Technical Bulletin

TITLE: DCS Compact MISC Card
DATE: May 14, 1998
ISSUED BY: TECHNICAL SUPPORT DEPARTMENT

BULLETIN NO.: TB 9804
NO. OF PAGES: 1 of 1

Figure 7-7

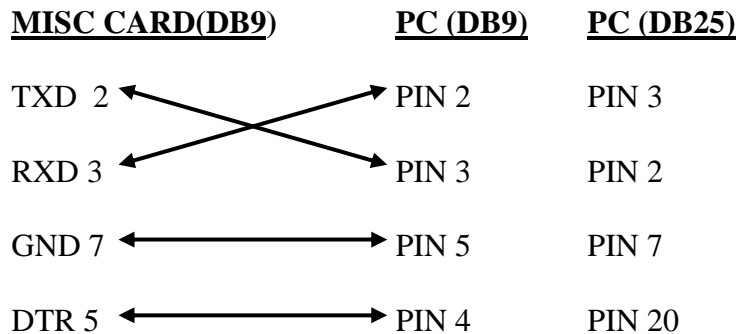
There is some confusion regarding the serial cable connections on the MISC and MISC2 cards in the DCS Compact.

The diagrams in the DCS Compact Installation Section, figures 7-7 and 7-8, dated June 1995, should be changed to reflect the following pin connections:

PIN CONNECTIONS FOR MISC CARD TO PERSONAL COMPUTER
